Monticello Nuclear Generating Plant
Docket No. 50-263
Renewed Facility Operating License No. DPR-22

Monticello Nuclear Generating Plant: Sixth Six-Month Status Report in Response to June 6, 2013 Commission Order Modifying Licenses with Regard to Reliable Hardened Containment Vents Capable of Operation Under Severe Accident Conditions (Order EA-13-109), Phases 1 and 2 (TAC No. MF4376)

ENCLOSURE 2

**RESPONSES TO OPEN ITEMS
ASSOCIATED WITH NRC ORDER EA-13-109, PHASE 1**

Figure OI 2-1 - HCVS Nitrogen Pneumatic System

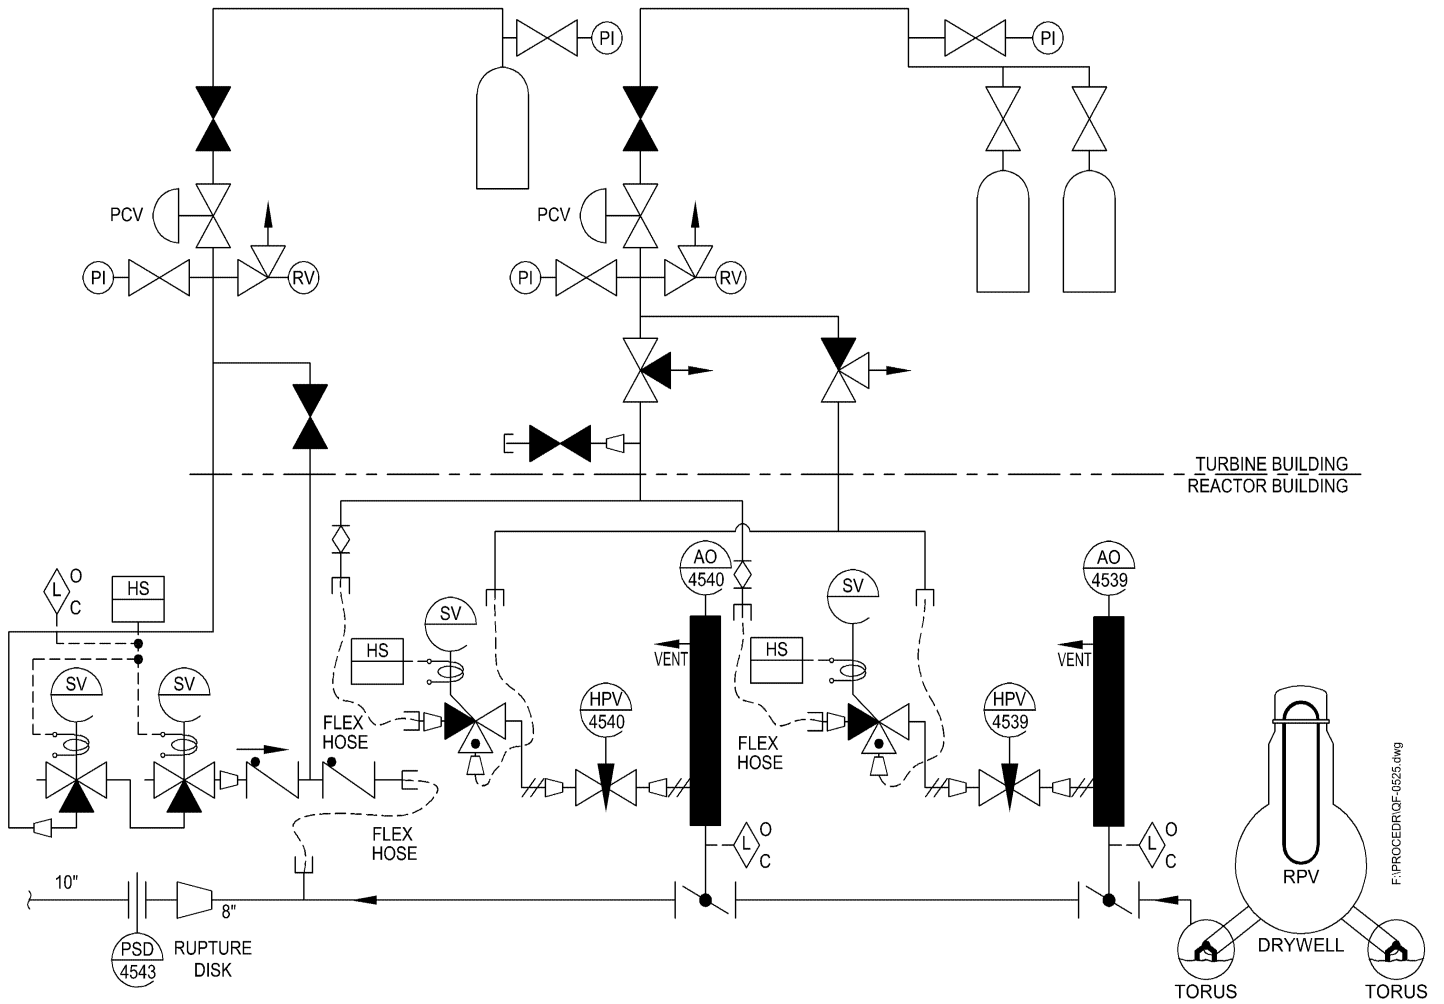
Open Item 2 - Design Information for HCVS Nitrogen Pneumatic System:

Make available for NRC staff audit documentation of the HCVS nitrogen pneumatic system design including sizing and location.

A calculation has been performed that confirms that the HCVS two (2) nitrogen supply systems that provide pneumatic capacity to the HCVS rupture disc and containment isolation valves are sized adequately. This calculation determined that one (1) nitrogen bottle is required to fully burst the HCVS rupture disc and two (2) nitrogen bottles are required to actuate the primary containment isolation valves over 24 hours.

Two (2) new nitrogen supply systems are installed in the 931' east Turbine Building with a remote manual operating station located south of the nitrogen bottles near the B Alternate Nitrogen supply. Pneumatic tubing was routed through the Turbine Building, Condenser Room, Reactor Core Isolation Cooling (RCIC) Room, and Torus Room to the HCVS rupture disc and containment isolation valves. The primary location for control of the HCVS remains in the third floor Emergency Filtration Train (EFT) Building at the Alternate Shutdown System (ASDS) panel.

The design of the new HCVS nitrogen system is provided in Figure OI 2-1 below.

A check valve is provided on the rupture disc pneumatic supply connection to the HCVS piping to prevent backflow to the remote operating station (see Figure OI 2-1 in Open Item Response 2). With exception of the rupture disc pneumatic supply, the HCVS piping is designed to have no interfaces with other plant systems, and all valves that open external to the system are designed to the system operating conditions. Once the rupture disk is burst the pneumatic supply will be isolated to prevent migration of hydrogen gas into the pneumatic supply system.
